ADDENDUM # 1 Questions and Clarifications

**Service Lane Renovation (General Contractor)
IFB #FED2019-13**

Addendum No. 1 has been prepared by Farnsworth Group containing two (2) pages and nine (9) drawings related to the Service Lane Renovations.

Project Name: Service Lane Renovation

1 FIRST FLOOR PLAN
Scale: 1/8" = 1'-0"

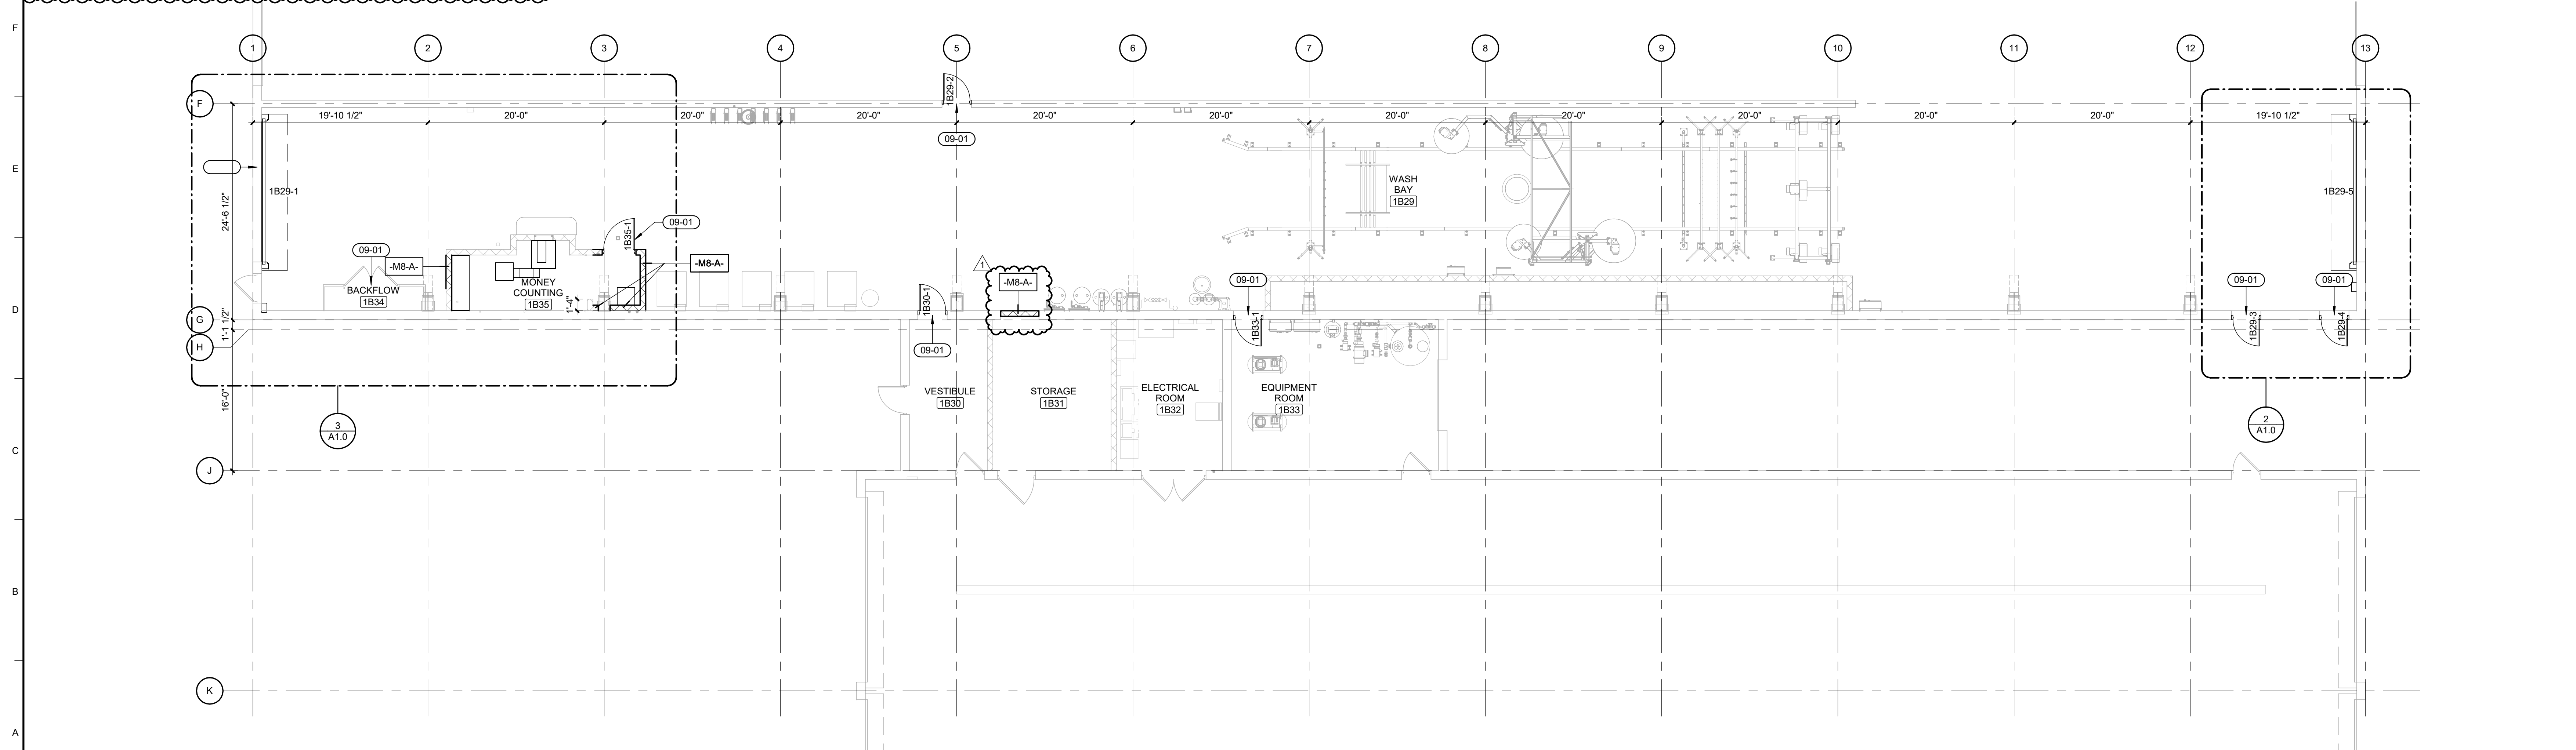
1. ADD: Attached drawings S0.1, S1.1, & S1.2.
2. REPLACE: Drawing A1.0 – FIRST FLOOR PLAN in its entirety with attached drawing A1.0.
3. REPLACE: Drawing E-101 – FIRST FLOOR PLAN in its entirety with drawing E-101
4. REPLACE: Drawing E500 – SCHEDULES in its entirety with the attached drawing E500 – SCHEDULES.
5. REPLACE: Drawing E601 – ONE LINE POWER DISTRIBUTION DIAGRAM in its entirety with attached drawing E601 – ONE LINE POWER DISTRIBUTION DIAGRAM.
6. REPLACE: Drawing ED101 – FIRST FLOOR DEMOLITION PLAN in its entirety with attached drawing E601 – ONE LINE POWER DISTRIBUTION DIAGRAM.
7. REPLACE: Drawings M1.1 – FIRST FLOOR MECHANICAL PLAN in its entirety with the attached M1.1 – FIRST FLOOR MECHANICAL PLAN.
